Arts Building Seismic Correction & Renewal
Project No. FM090010L/988720

Addendum No. 3

July 14, 2010

ADDENDUM NUMBER 3

E1.12BA

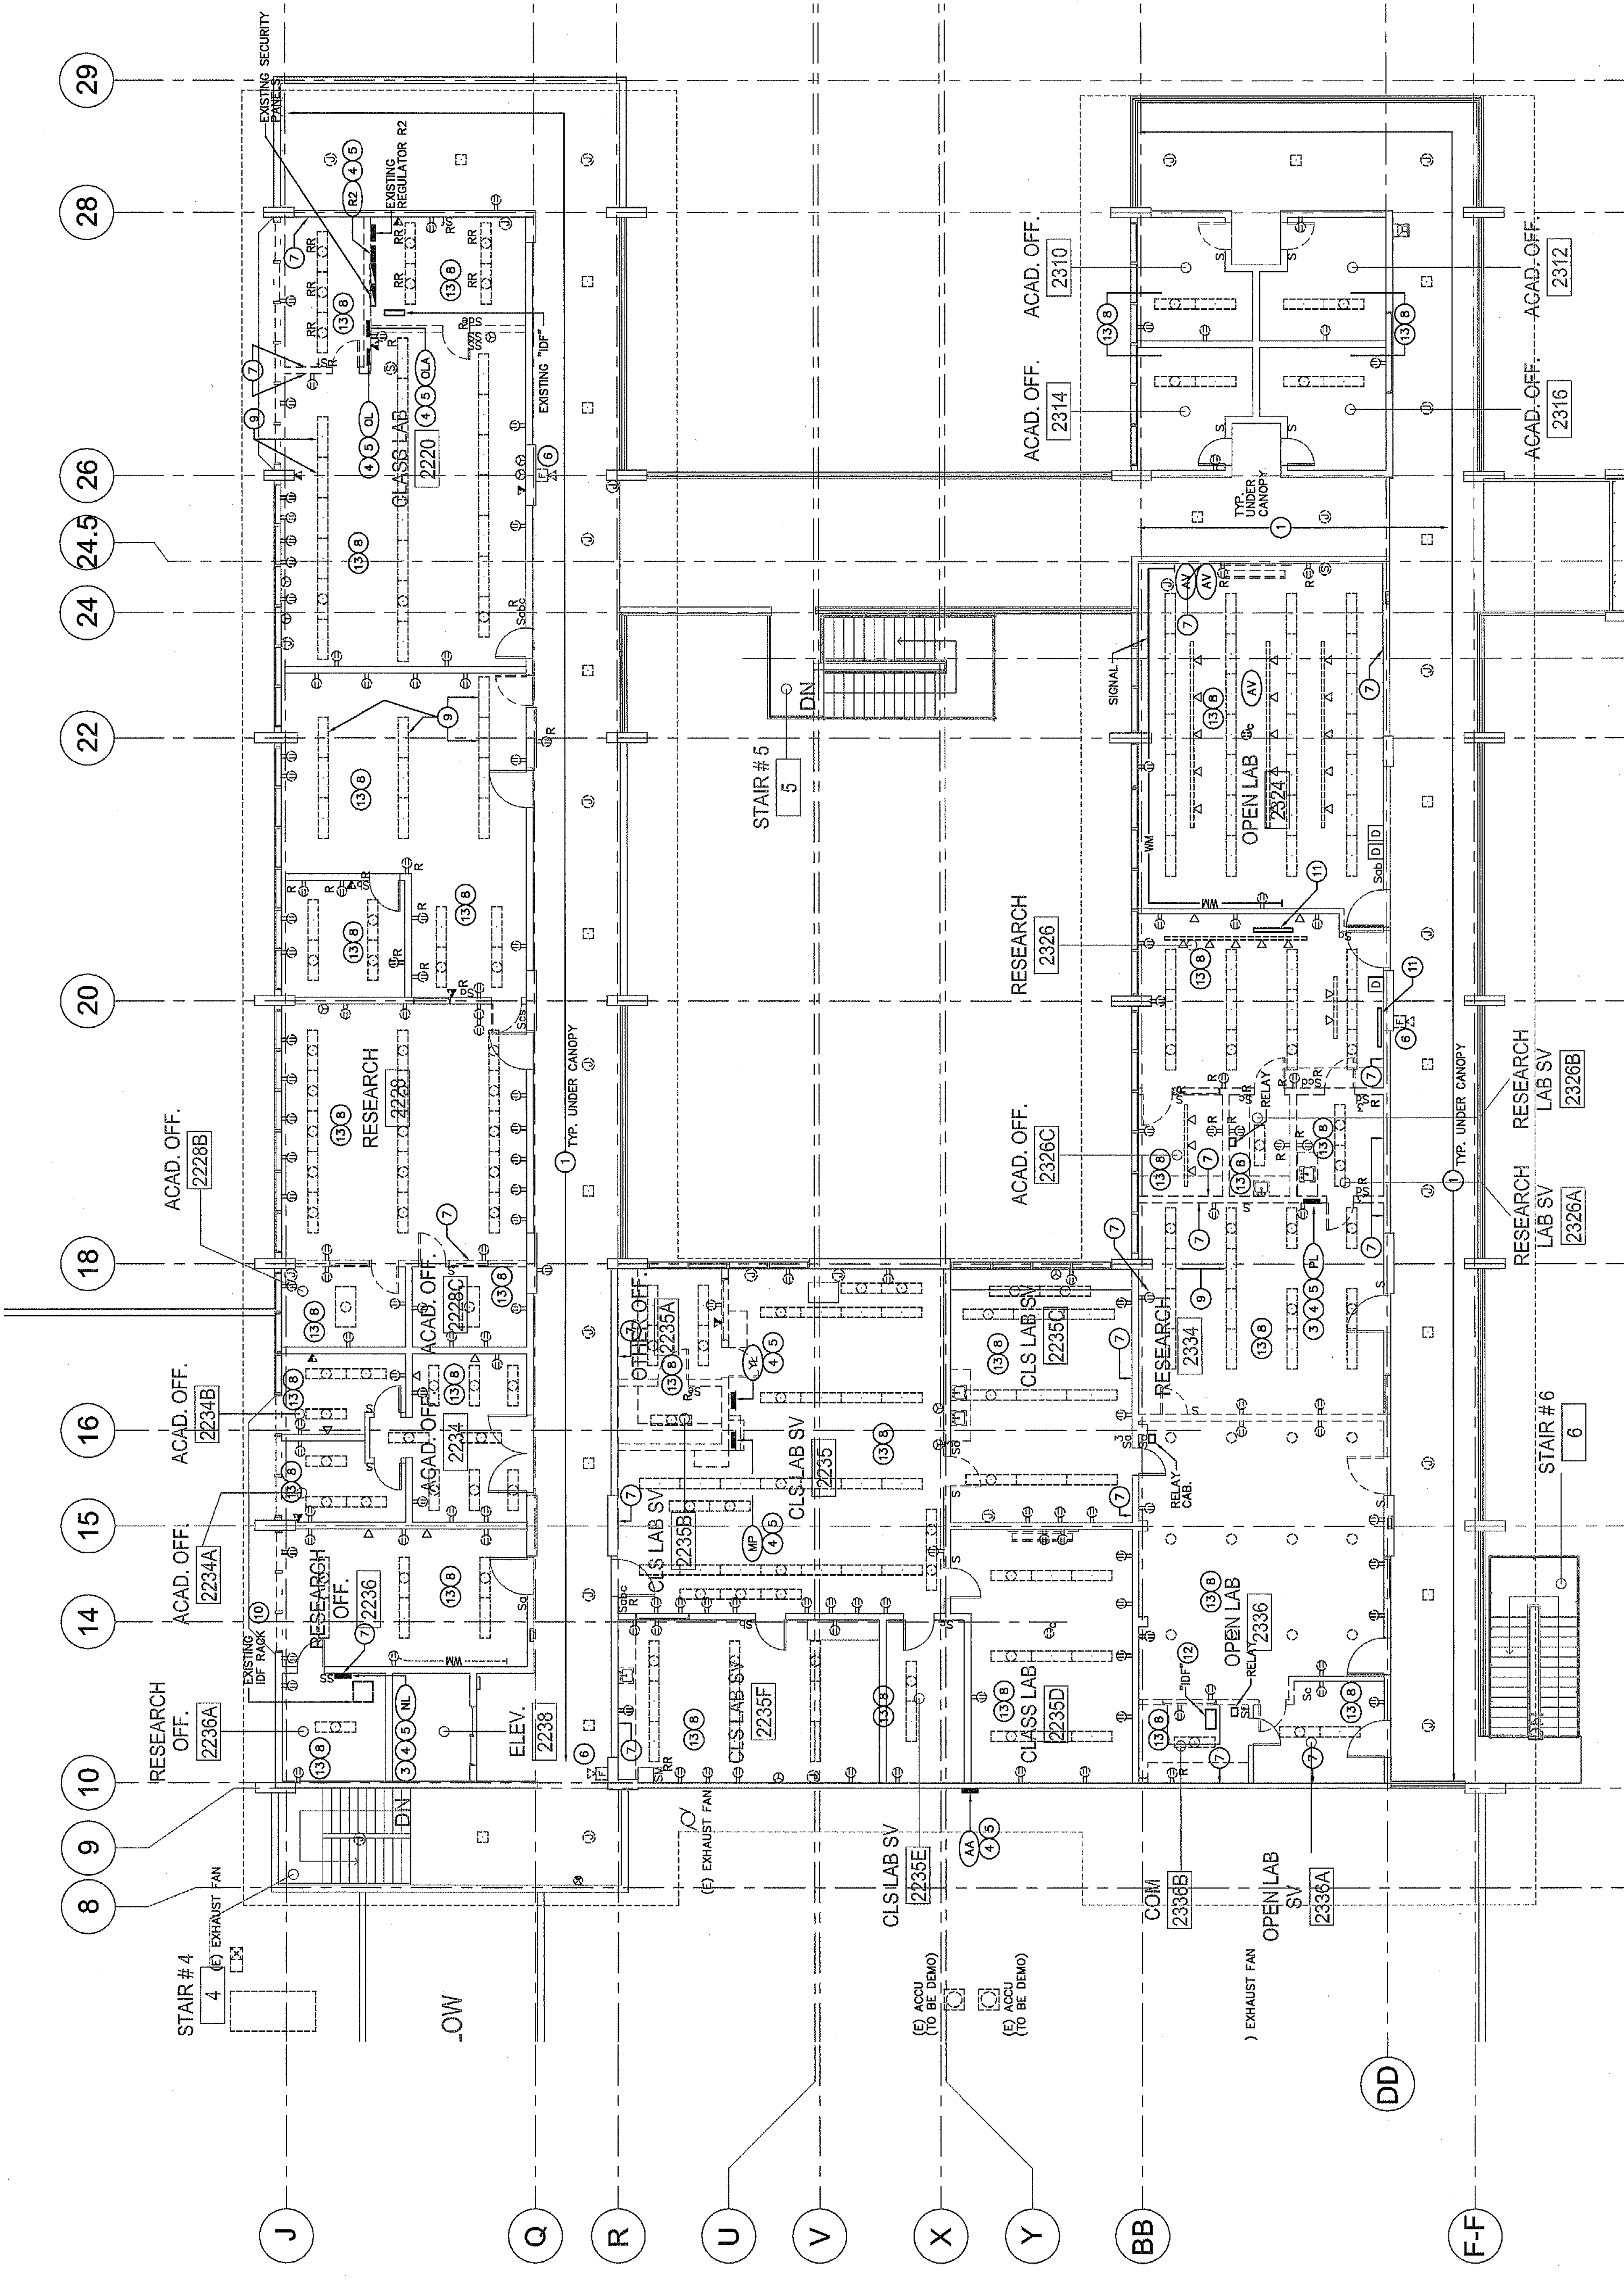
33. DRAWING NO. E1.12BA, SECOND FLOOR UNIT 2 DEMO PLAN-BASE BID, **Replace** in its entirety with attached drawing E1.11BA, dated 7/8/2010.

E2.10BP
UCSB DRAWING NO. 594-301.
STUDIOS PROJECT N.O. 10302.00

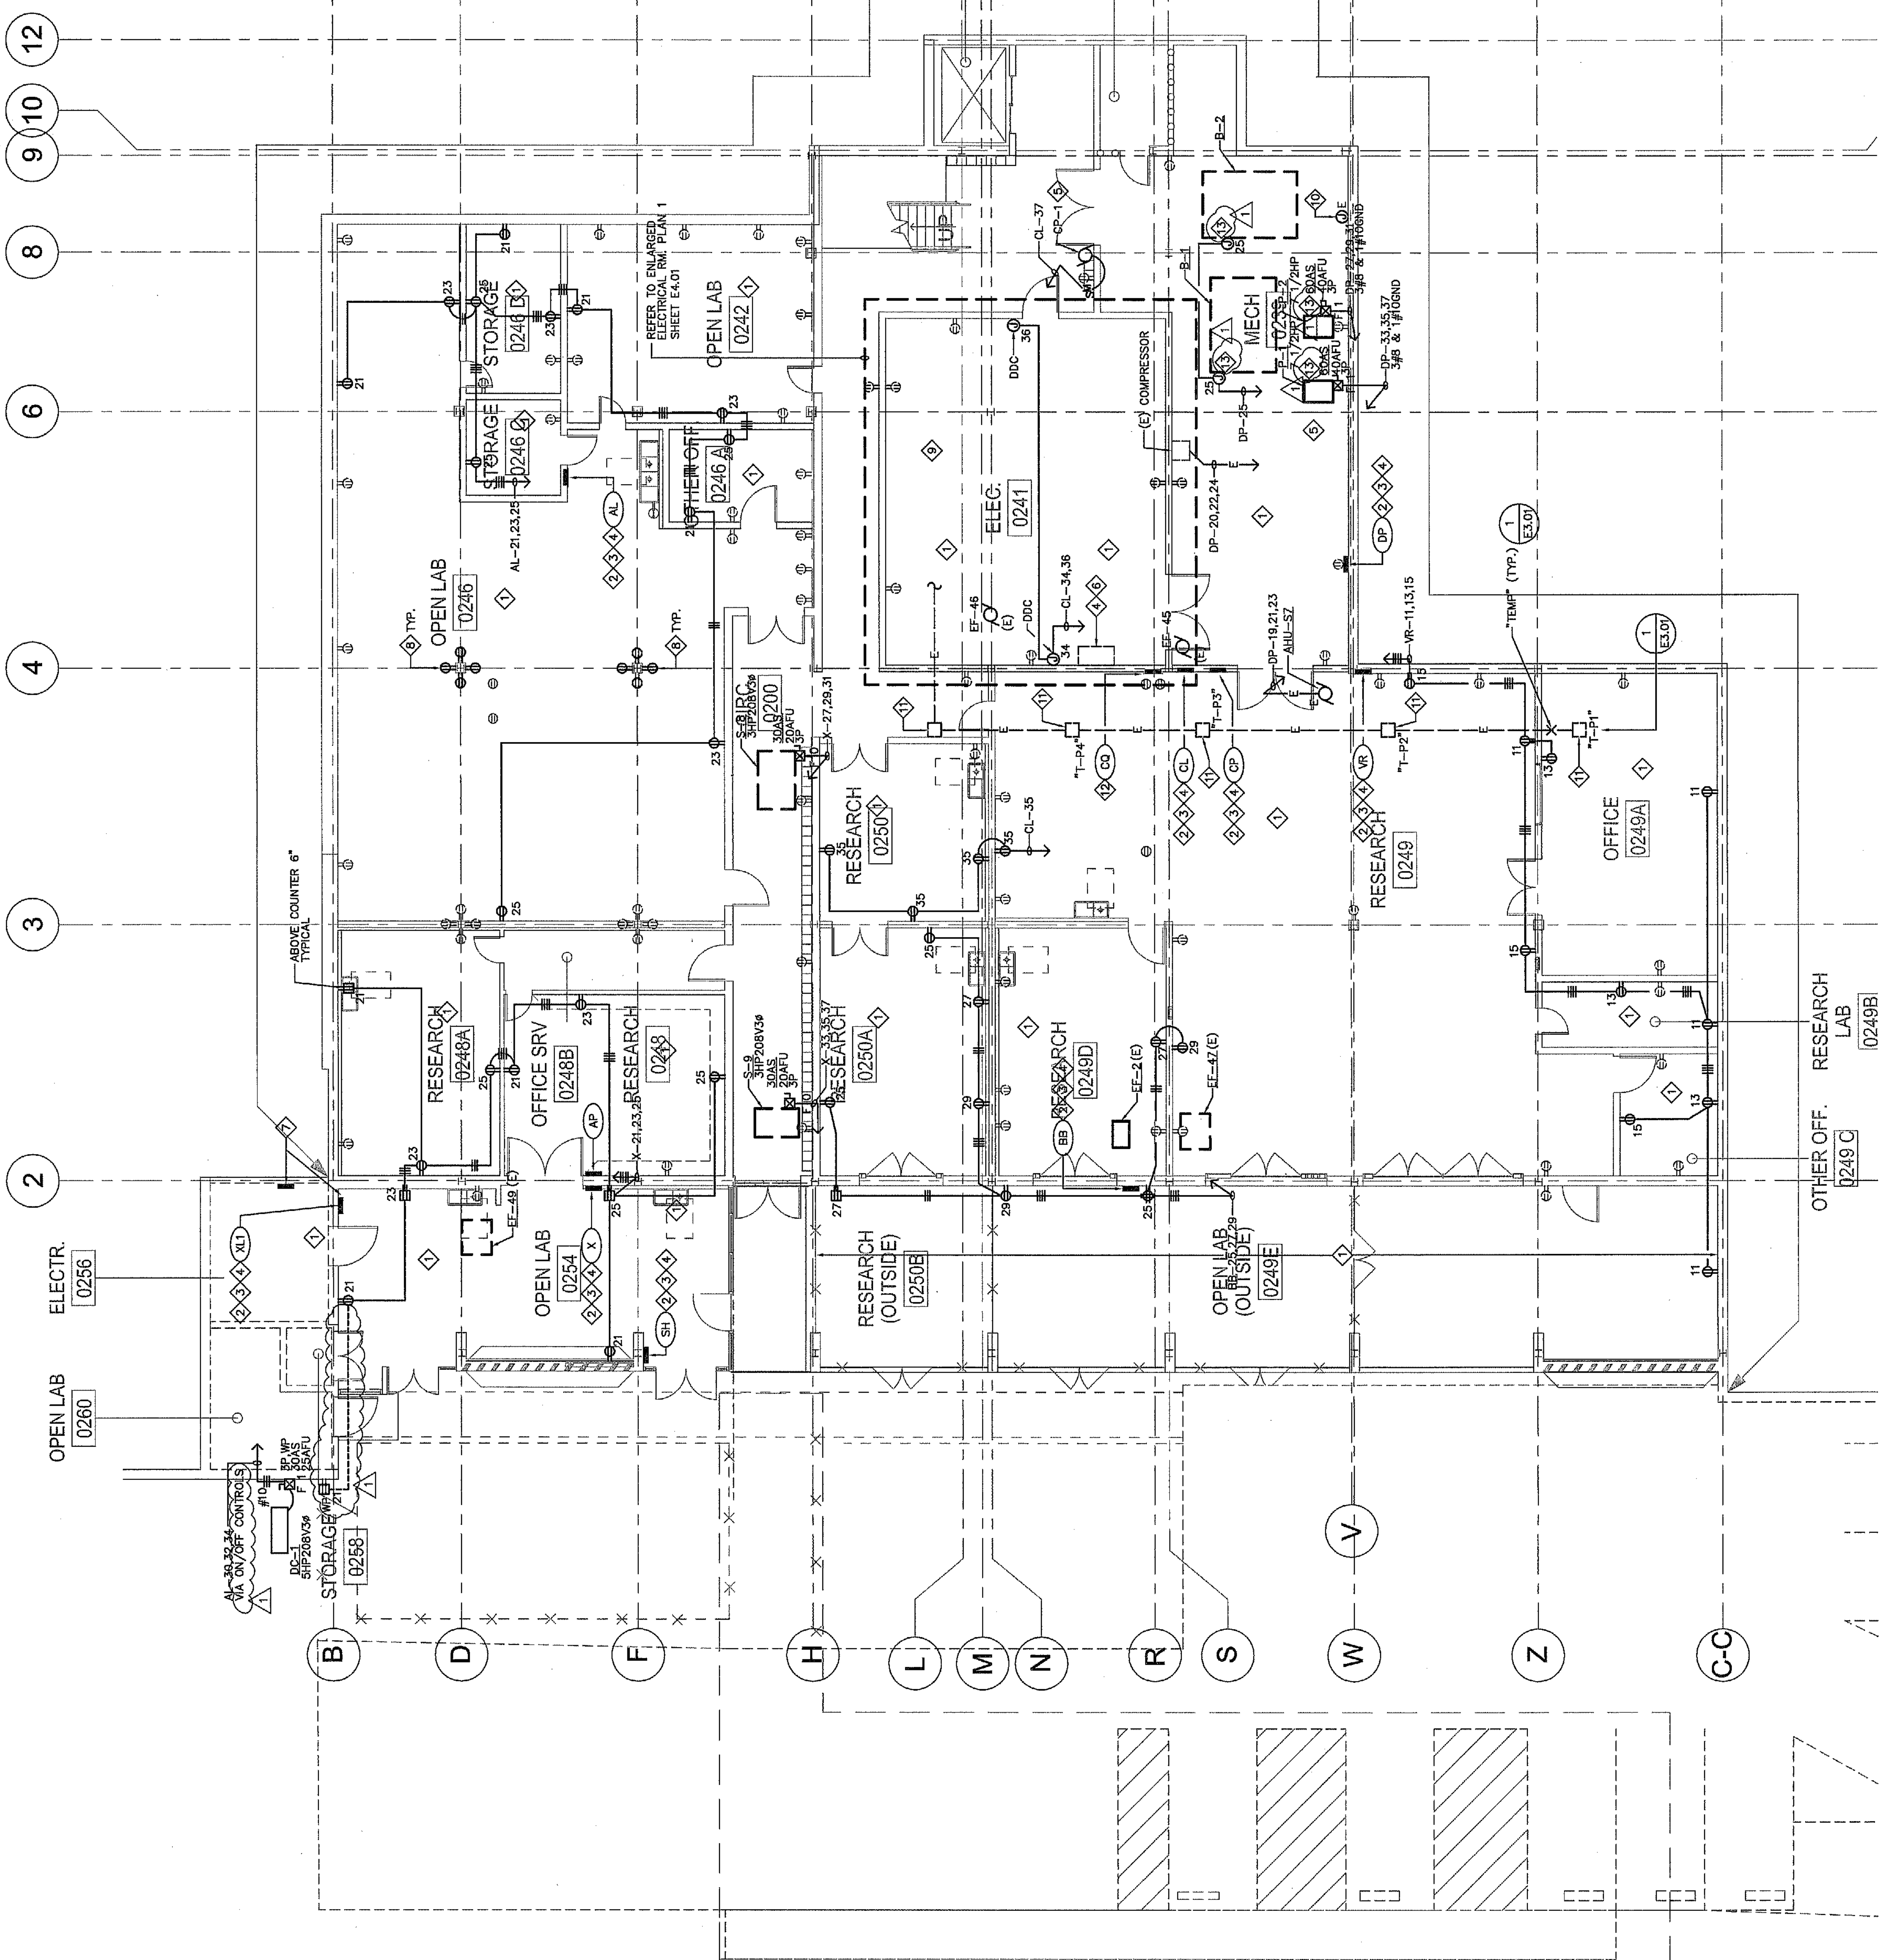
34. DRAWING NO. E2.10BP, BASEMENT UNIT 2 REMODEL POWER PLAN, **Replace** in its entirety with attached drawing E2.10BP, dated 7/8/2010.

E2.12BLA
UCSB DRAWING NO. 534-301.

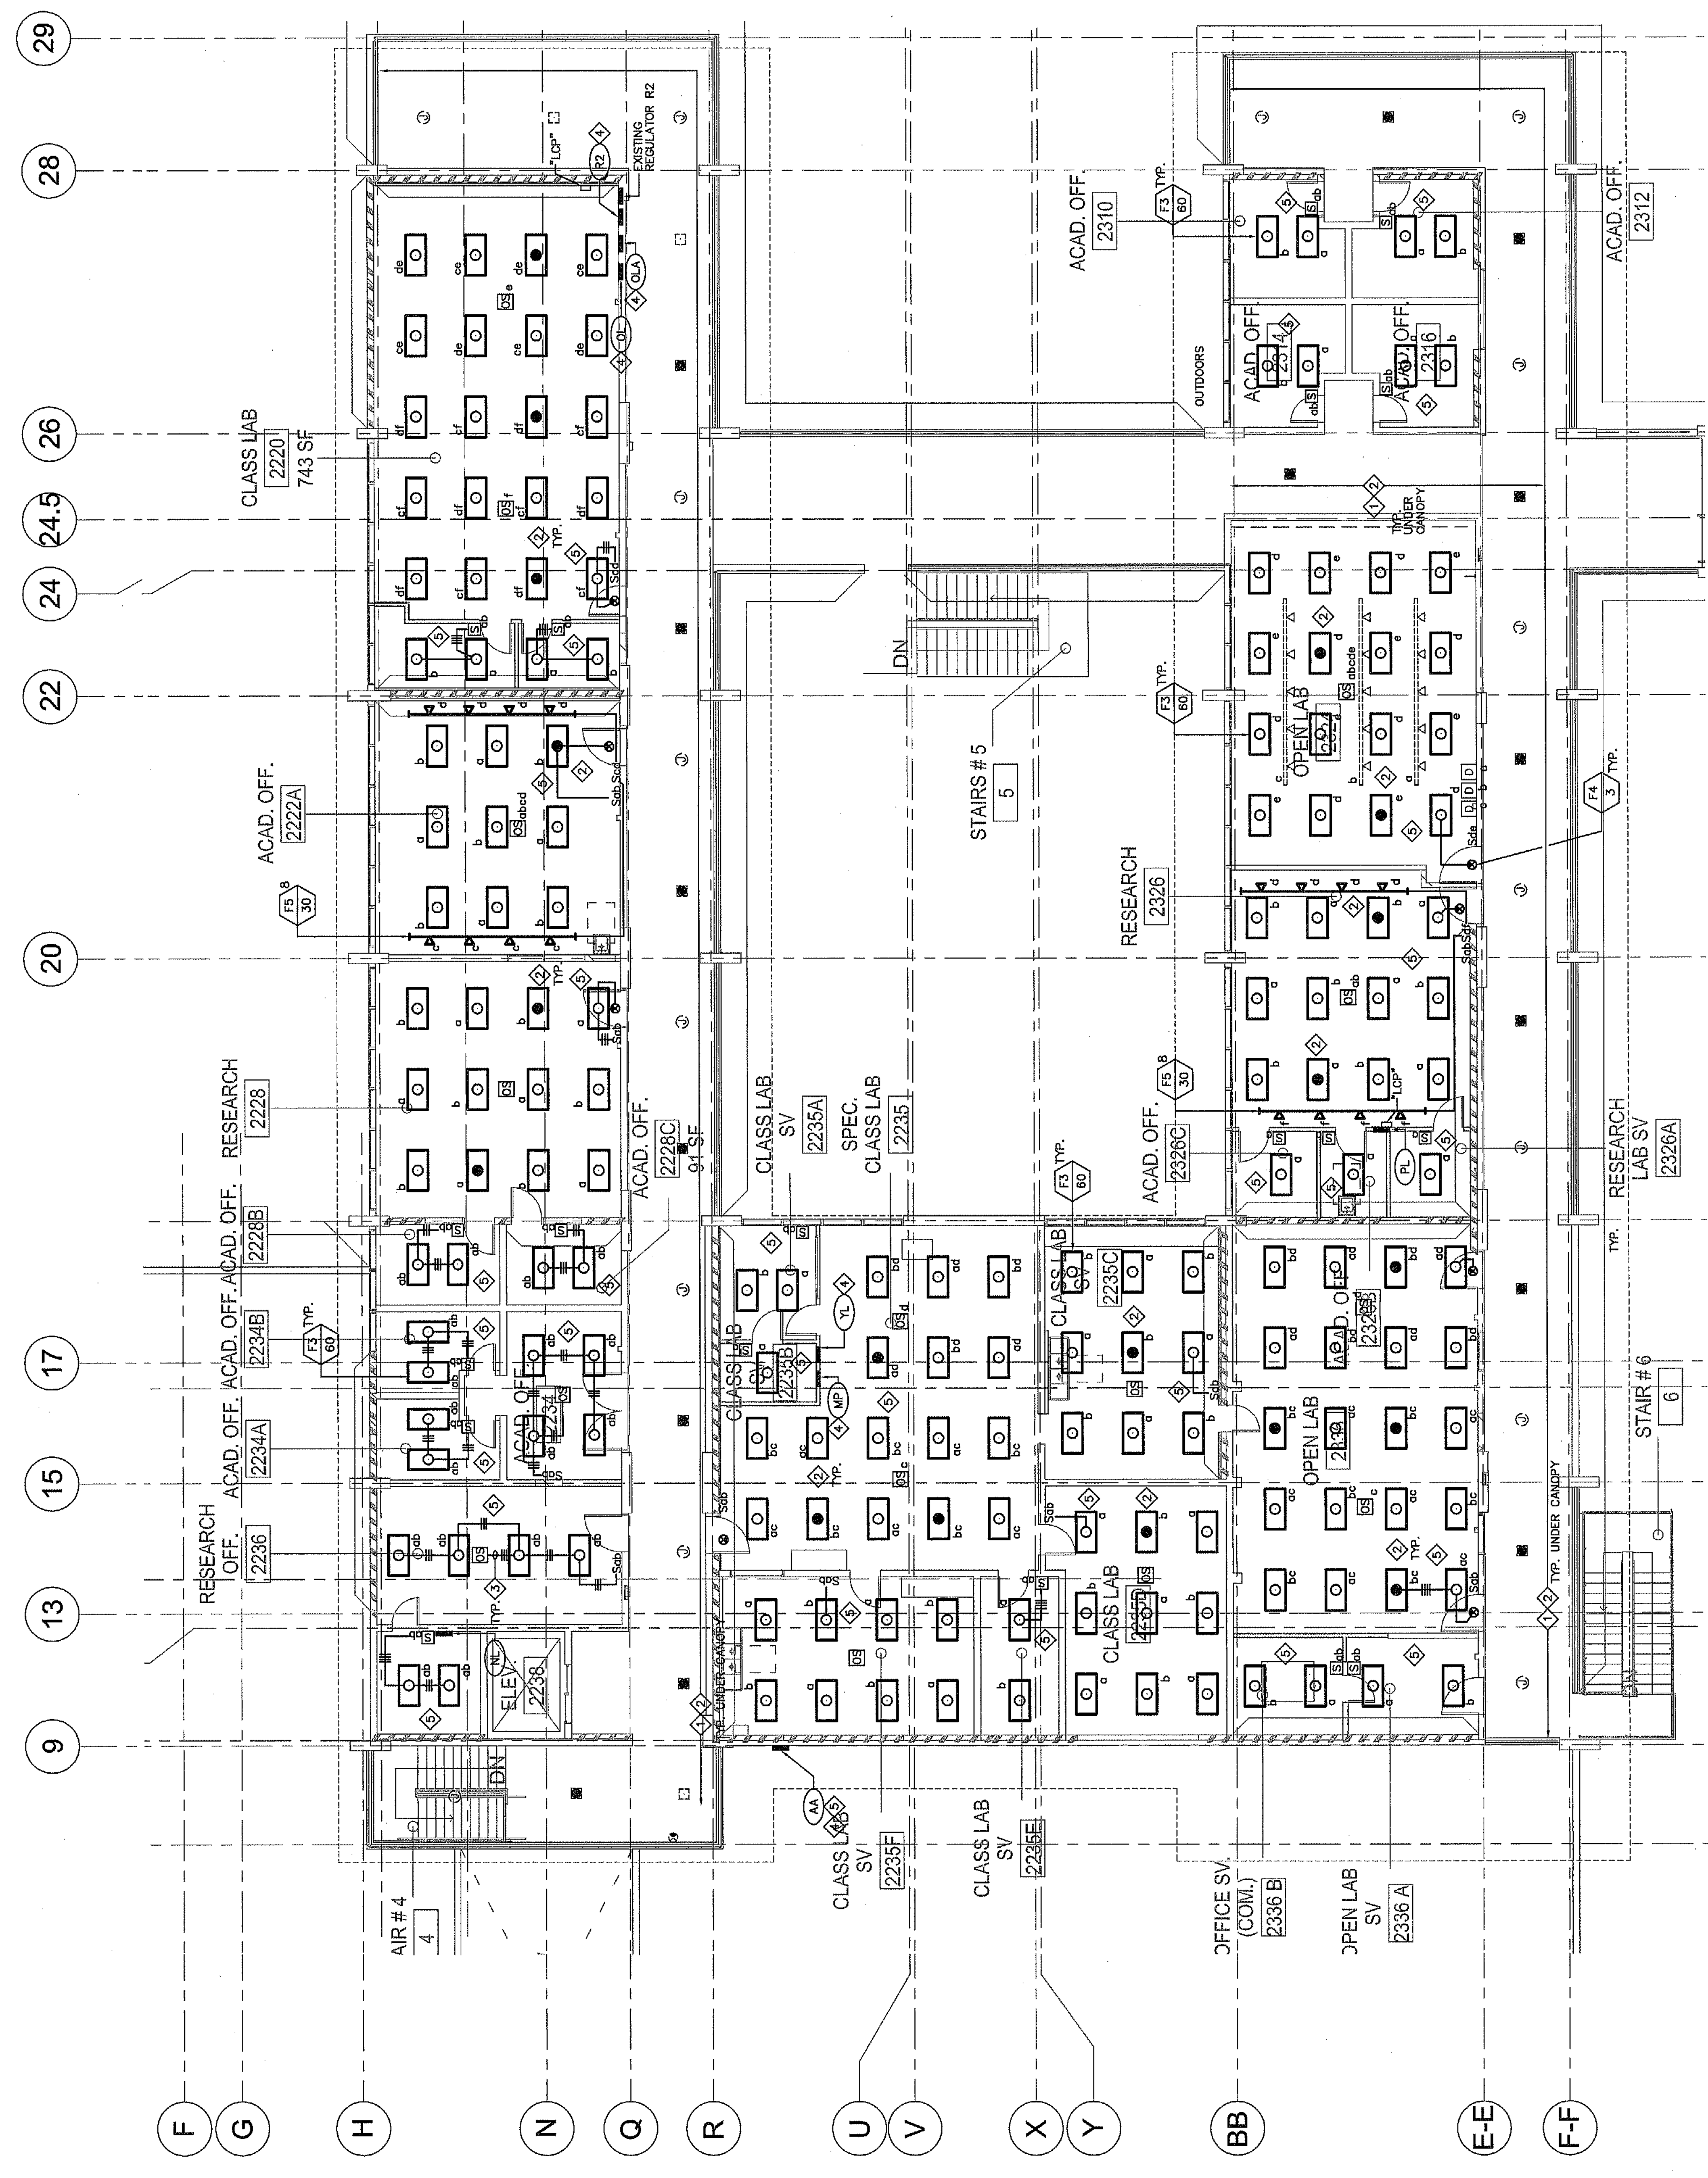
35. DRAWING NO. E2.12BLA, SECOND FLOOR UNIT 2 REMODEL LIGHTING FLOOR PLAN- ALTERNATE A, **Replace** in its entirety with attached drawing E2.12BLA, dated 7/8/2010.
